# Lochill Farm Stream Mitigation Project Year 1 (2019) Monitoring Report Final

DMS Project ID No. 97083, DEQ Contract No. 6828  
USACE Action ID No. SAW-2016-00881, DWR# 16-0370  
Orange County, North Carolina, Neuse River Basin: 03020201-030030  
MY1 Data Collection Period: October 2019

**Subject:** Response to DMS Comments for DRAFT MY1 Report  
Lochill Farm Stream Mitigation Project, Orange County  
DMS Project # 97083, DEQ Contract #6828, Neuse-01 River Basin

**Figure 2**  
**Project Asset Map**  
**(Stream and Riparian Buffer)**  
**Lochill Farm Site**

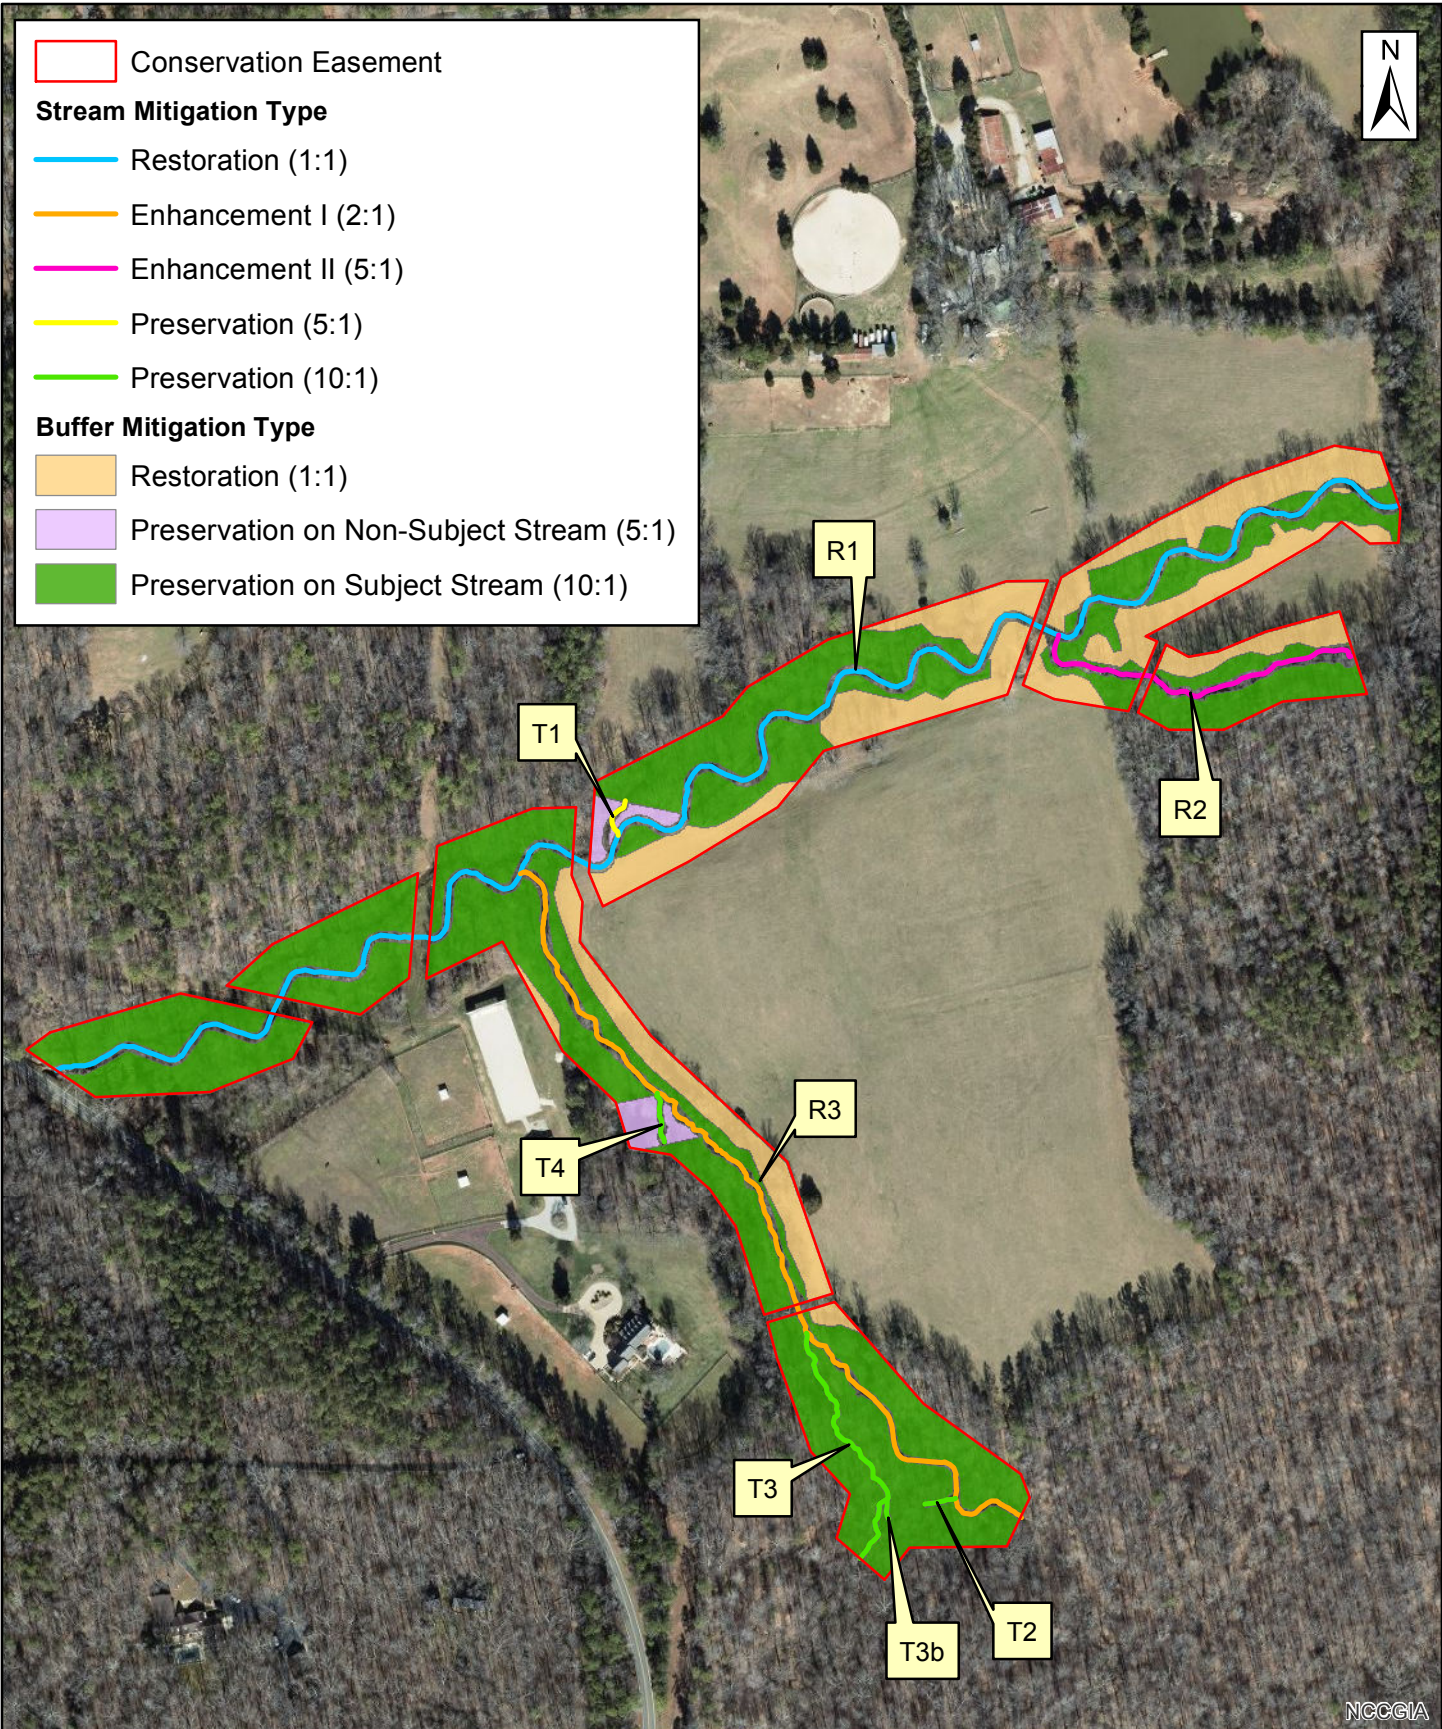
- Add a map with riparian buffer assets (Figure 2 in the Baseline/MY0 report).

**Response:** Revision made as requested.
